# **Pentium<sup>®</sup> II Processor Specification Update**

Release Date: September 1997

Order Number: 243337-005

Figure 7. S.E.C. Cartridge Bottom Side View

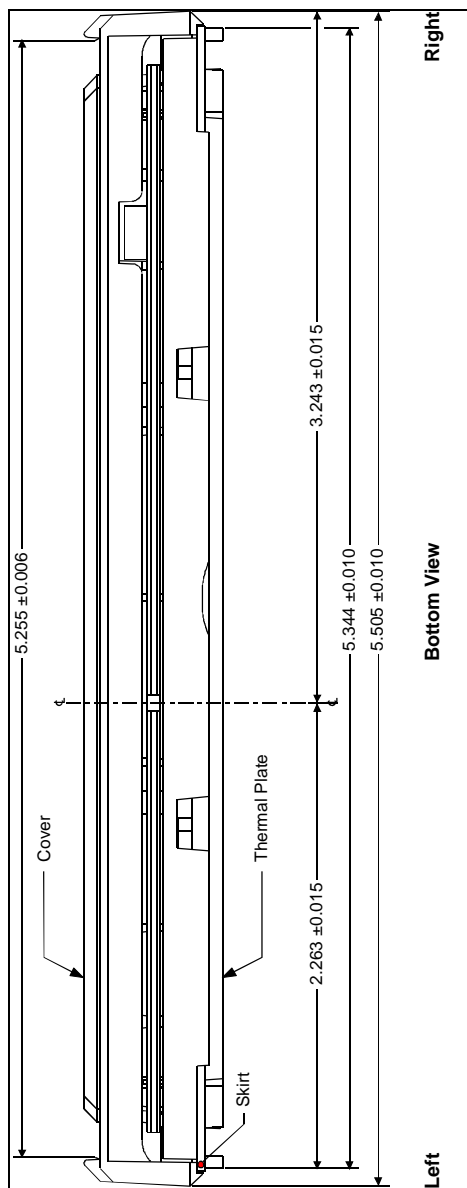
\*\* Added Figure 9, Figure 7 corrected a dimension, Figure 8 clarified dimensions, Figure 10 corrected dimensions

The S.E.C. cartridge mechanical specifications provided in the *Pentium® II Processor at 233 MHz, 266 MHz and 300 MHz* datasheet contained incorrect tolerance information for some dimensions. Also, some of the information provided in the figures was duplicitous and not required to accurately use and design for the S.E.C. cartridge package. The revised figures provided in this section are meant to replace Figures 29 through 42, Table 23 and the accompanying notes found on page 44.

**Figure 12. Heatsink Attachment Mechanism Design Space**

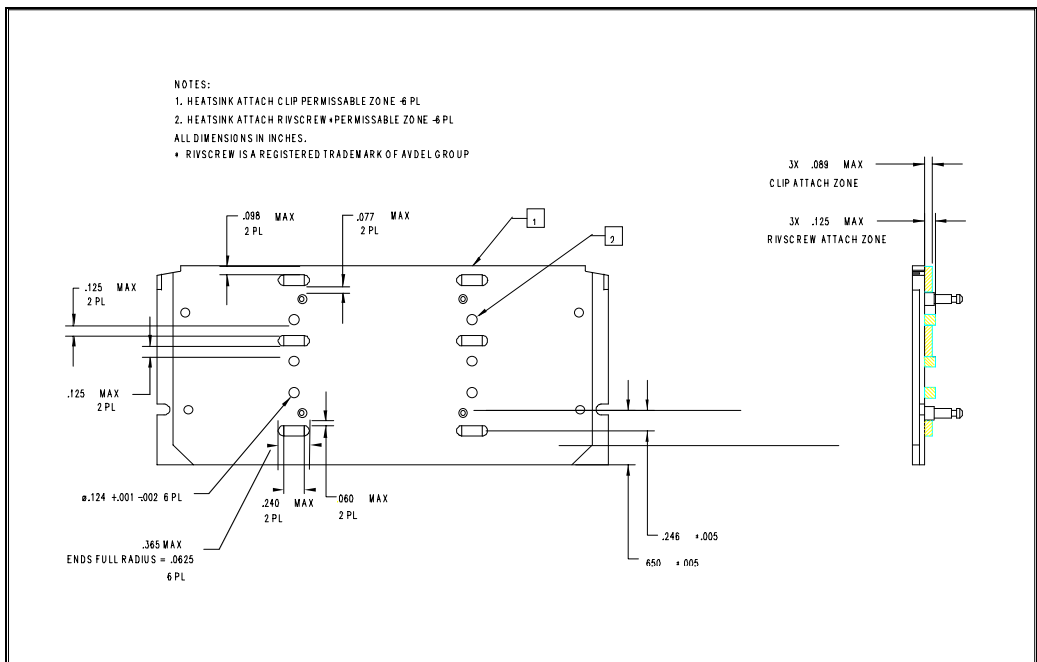
A change to the attach mechanism specification is provided below. The original specification for clearance of heatsink attach solutions is provided in Section 4.3 (and Figure 23 and Figure 24) in the *Pentium® II Processor at 233 MHz, 266 MHz and 300 MHz* datasheet. Figure 11 shows the revised maximum specifications for heatsink clip and Rivscrew® attach mechanism designs. All heatsink clip and Rivscrew attachment solutions must remain within the respective maximum “permissible” zone as detailed in Figure 11.

The thermal plate shown in Figure 11 is used to portray the heatsink attach mechanism design space for the future Slot 1 processors. However, the maximum “permissible” design space is also valid for both the current Pentium II and future Slot 1 processors.

Please review the proposed specifications to guarantee compatibility with existing Pentium II and future Slot 1 processor heatsink attachment solutions. Note that the required heatsink attachment solution space should not exceed the maximum proposed design space while installed or during the installation and removal procedure.
